10GBASE-T Transmitter PSD

Sandeep Gupta (Teranetics), Ramin Shirani (Aquantia)

Proposal for PSD

PSD curves with assumptions as stated

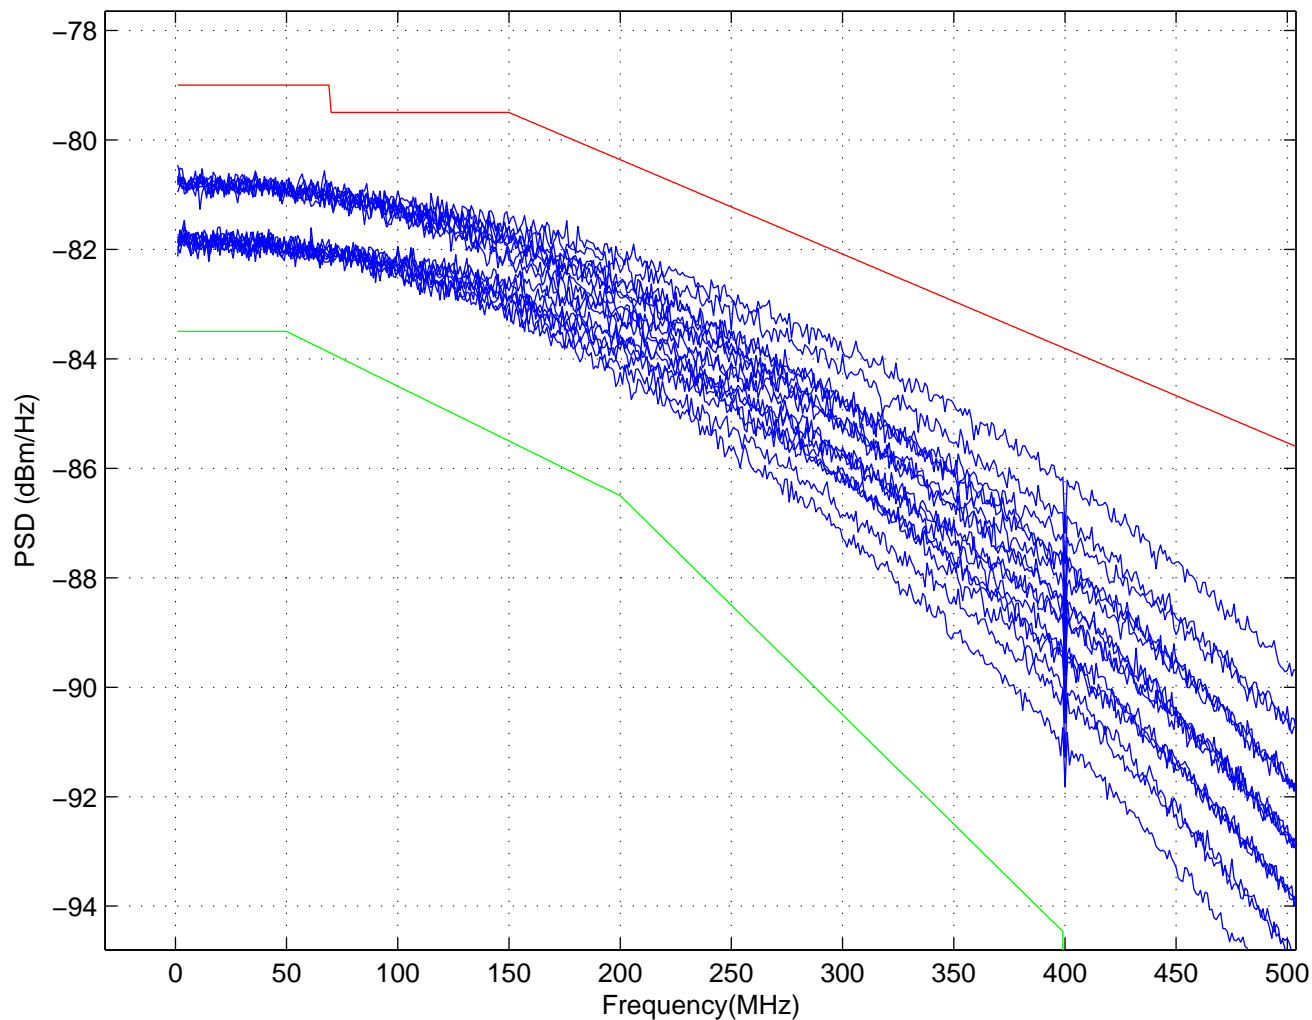
- With 2V +/- 6% at the transformer output, the lower PSD curve has smaller margin at lower end.
- 2V +/- 6% with the filter tolerances as specified meets the power spec
- Upper PSD has a larger margin, especially the lower 0-70MHz range.

Recommendation:

Reduce the upper PSD by 1dB in 0-70MHz.

0.5dB reduction on upper and lower curves everywhere else w.r.t. draft 2.1, would make it better centered.

PSD upper curve:

- 79 dBm/Hz, $0 < f \leq 70$
- 79.5 dBm/Hz, $70 < f \leq 150$
- $-79.5 - (f - 150)/58$ dBm/Hz, $150 < f \leq 730$
- $-79.5 - (f - 330)/40$ dBm/Hz, $730 < f \leq 1810$
- 116 dBm/Hz, $1810 < f < 3000$

PSD lower curve:

- 83.5 dBm/Hz, $5 < f \leq 50$
- $-83.5 - (f - 50)/50$ dBm/Hz, $50 < f \leq 200$
- $-86.5 - (f - 200)/25$ dBm/Hz, $200 < f \leq 400$

Where f and the ranges are in MHz
